Re: 2BM-ULU1520 - Bonito Capital Corporation - Ulu Gold Project - Assignment **Application**

Review Memorandum

Re: Water Licence Assignment Application, #2BM-ULU1520

RECLAIM Cost Model for the Ulu Mine, Nunavut

PHOTO LOG

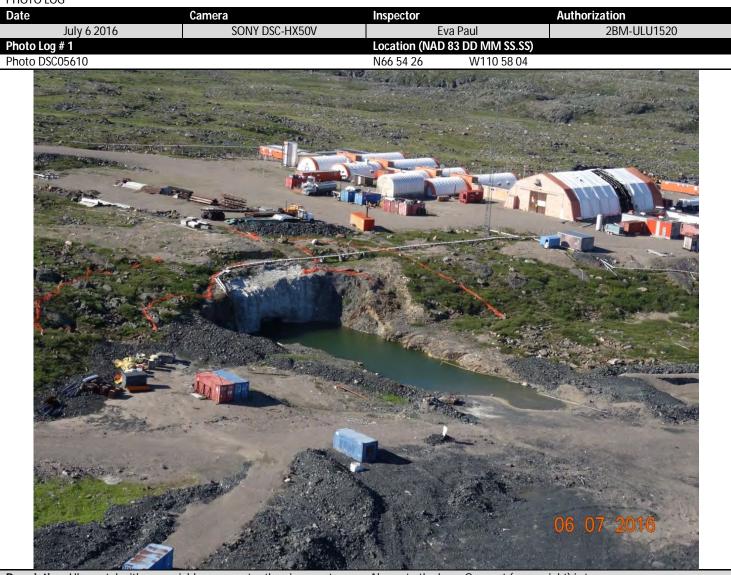
Description: Barrels of assorted and potentially hazardous waste remain on the mine storage pad. Other waste (not shown here) remains elsewhere on site, including the waste rock storage pad, and near the helipad.
